VALUE ENGINEERING TRAINING STUDY REPORT

US 441 - Widening and Reconstruction

Project No. EDS-441(47)

PI No. 422420

Idea No.:
Client: A-2
GDOT

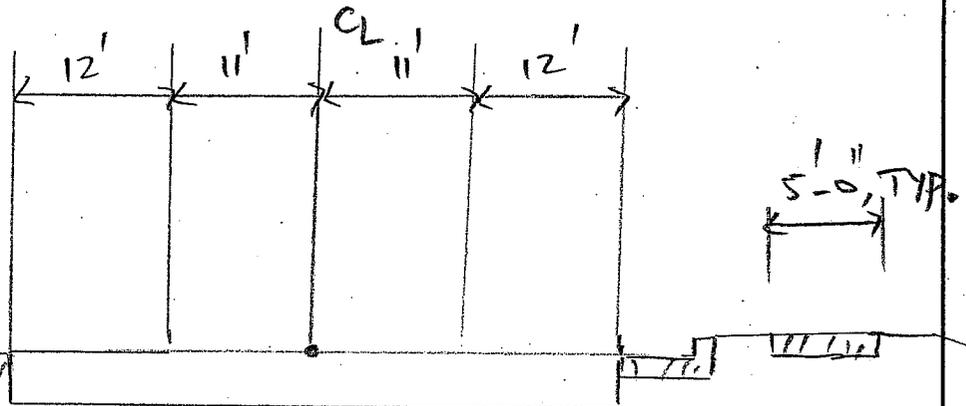
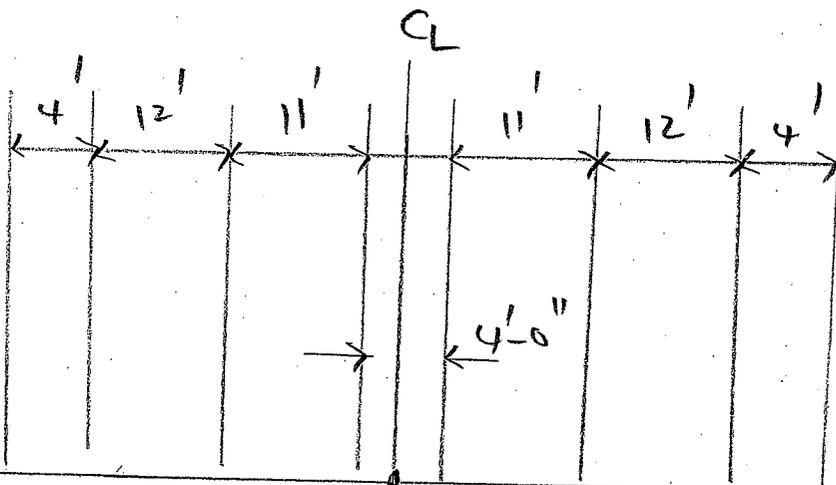
DEVELOPMENT AND RECOMMENDATION PHASE			
Project: EDS00-0441-00(047) CLINCH COUNTY			
Idea No.: A-2	Sheet No.: of	CREATIVE IDEA: Eliminate/Reduce median width	
Comp By: VN		Date: 10-22-09	
Checked By:		Date:	
<p>Original Concept: 32' depressed median</p> <p>Proposed Change: 4' flush median in rural section and no median in urban section</p> <p>Justification: This is the G.R.I.P project. The design speed is 45 mph and really low volume of traffic. Existing 2 lanes work fine with current capacity. With additional 2 lanes, capacity will be significantly reduced. Therefore, eliminate or reduce the median will not jeopardize the safety issue. However, this will be a significant reduction of cost for ROW and Earth Work.</p>			
LIFE CYCLE COST SUMMARY	INITIAL Project Cost	FUTURE Project Cost	TOTAL Present Worth Cost
INITIAL COST: Original	\$336,211		
Proposed	\$126,346		
Savings	\$210,000		
FUTURE COST: Savings			0

ORIGINAL - 4-12' LANES WITH 32' MEDIAN.

STA 163+00 TO STA 213+00
NO 4' FLUSH MEDIAN.

STA. 126+00 TO STA 163+00
STA 213+00 TO STA 258+59.51.
4'-0" FLUSH MEDIAN.

Idea No.: A-3
Client: GDOT

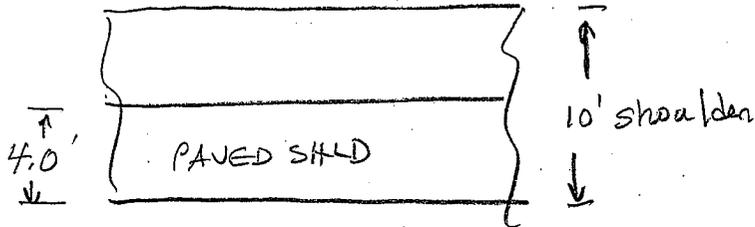
DEVELOPMENT AND RECOMMENDATION PHASE			
Project: EDS00-0441-00(047)			
Idea No.: A-3	Sheet No.: of	CREATIVE IDEA: Reduce Paved Shoulder Width	
Comp By: LS		Date: 10-22-09	
		Checked By: Date:	
<p>Original Concept:</p> <p>Original concept proposed 6.5 ft. paved shoulders.</p> <p>Proposed Change:</p> <p>The proposed change is to reduce the paved shoulder width to 4.0 ft.</p> <p>Justification:</p> <p>This is a GRIP project with low traffic volumes (2007 ADT 3250 and 2027 ADT 5210) and low posted speeds. Reducing the paved shoulder width will reduce the asphalt and GAB quantities while maintaining an adequate paved shoulder. The 10 ft overall shoulder width is not changing.</p>			
LIFE CYCLE COST SUMMARY	INITIAL Project Cost	FUTURE Project Cost	TOTAL Present Worth Cost
INITIAL COST: Original	\$230,800		
Proposed	\$152,000		
Savings	\$79,000		
FUTURE COST: Savings			
TOTAL PRESENT WORTH SAVINGS			\$79,000

Idea No.: B-3
Client: GDOT

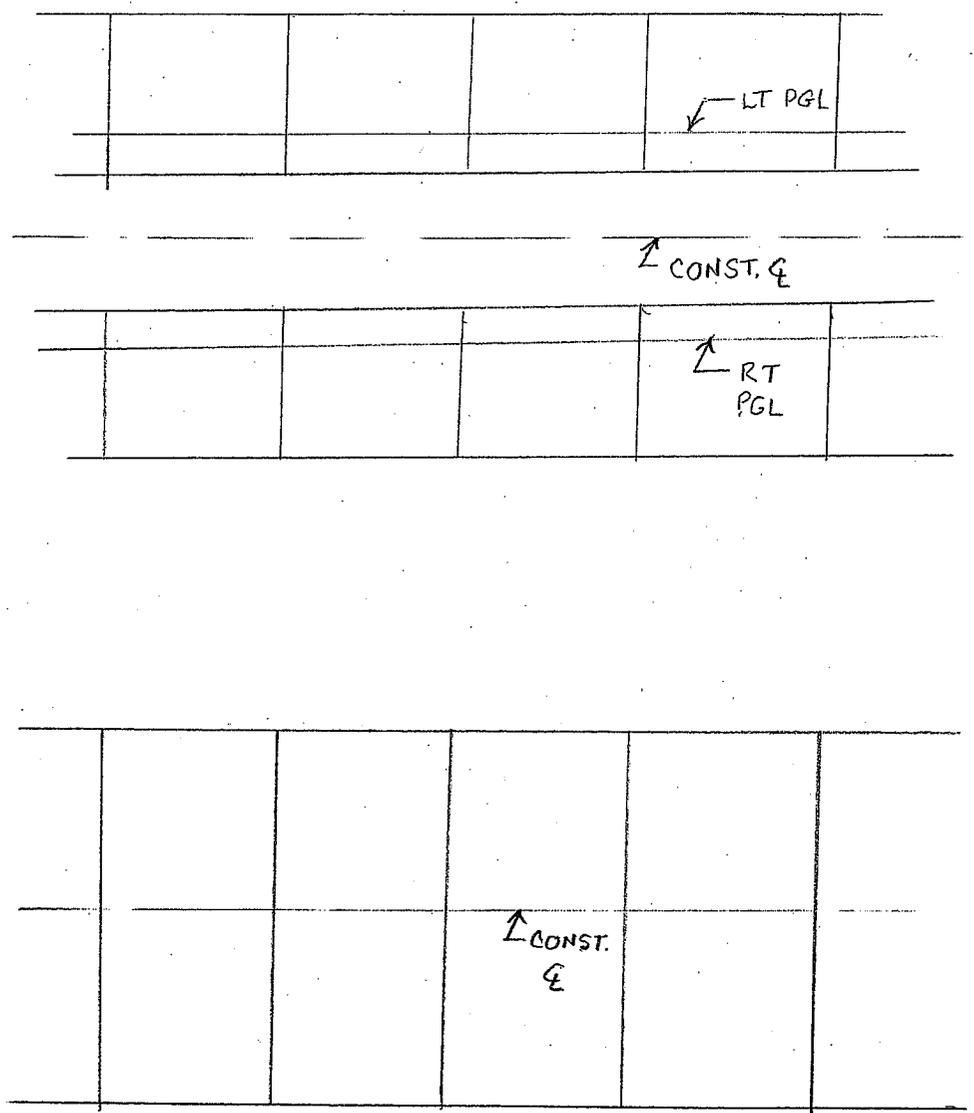
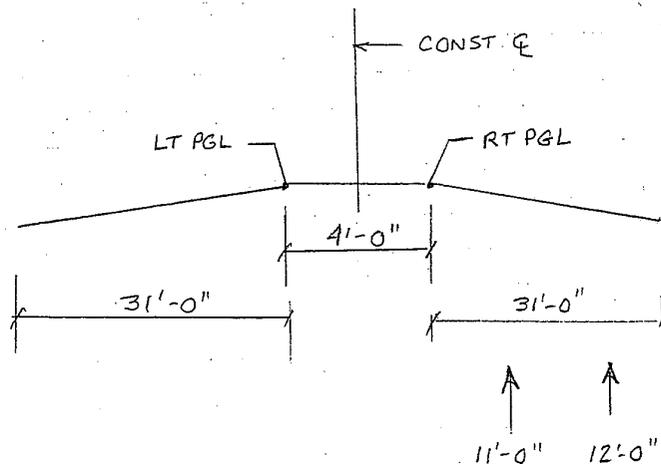
To replace existing bridges 1 and 2 with double bridges. (4 total bridges)

To replace existing bridges 1 and 2 with single bridges. (2 total bridges)

Traffic volume in the GRIP corridor (3250 ADT for 2007 and 5210 ADT for 2027) does not warrant the use of two double bridges nor does the design speed.
The proposed change to single bridges, carrying four lanes of traffic, will generate significant cost savings and match the proposed roadway typical section.

COST ESTIMATE FROM PLANS = \$82.5/FT² ; SHOULD BE \$95/FT²

Idea No.: C-5
Client: GDOT

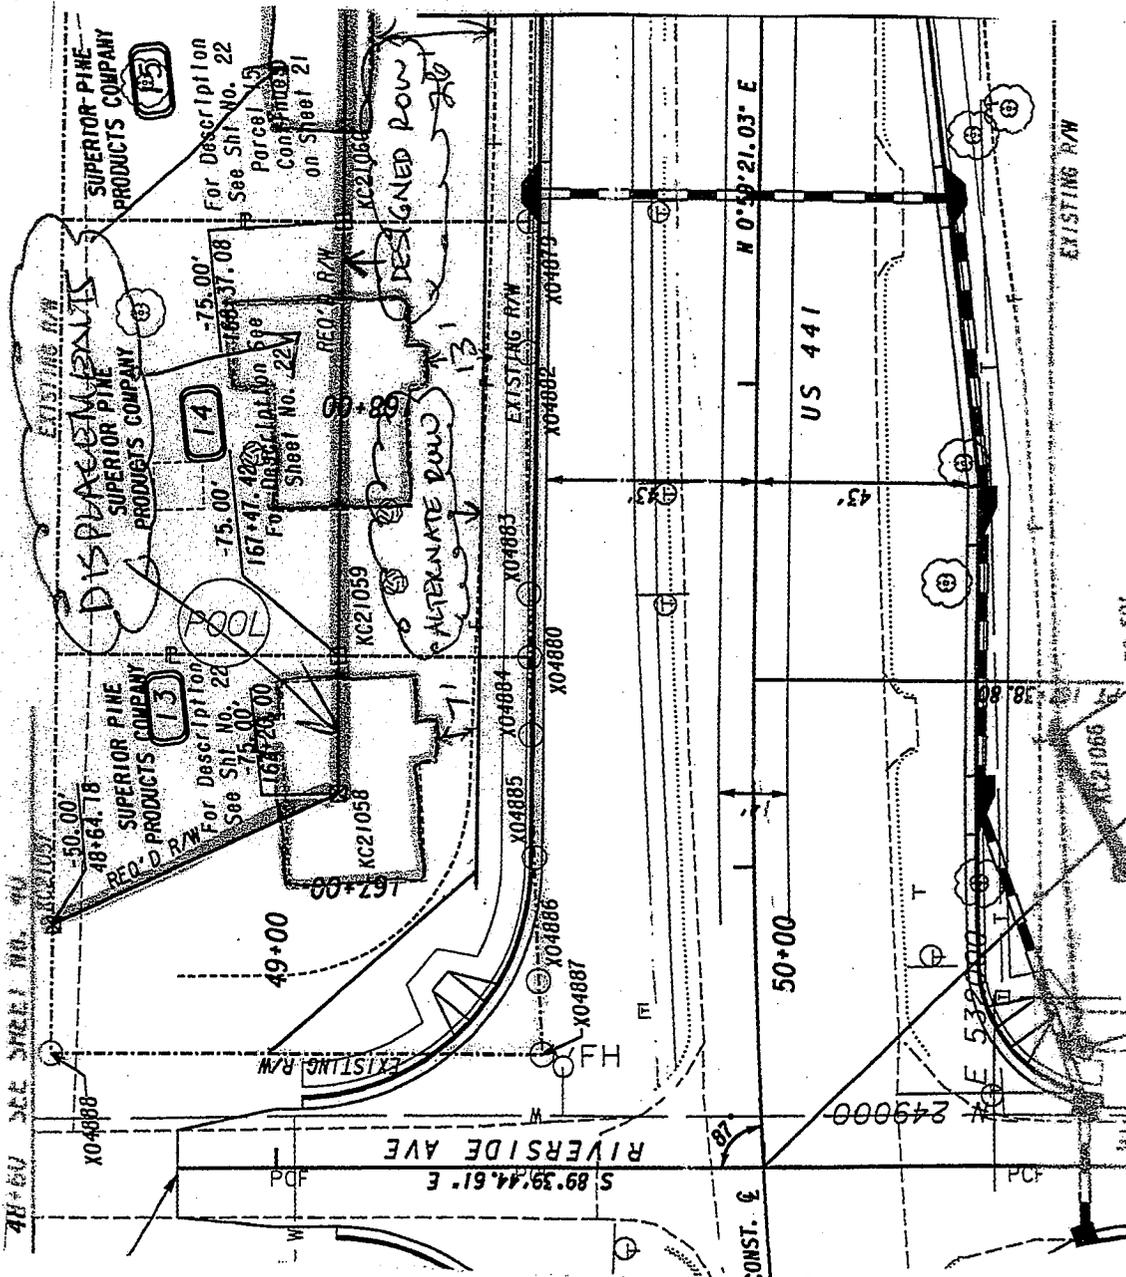
Required ROW placed 20' to 30' beyond construction limits in some locations

Pull in required ROW to be 10' to 20' beyond construction limits

Saves ROW costs
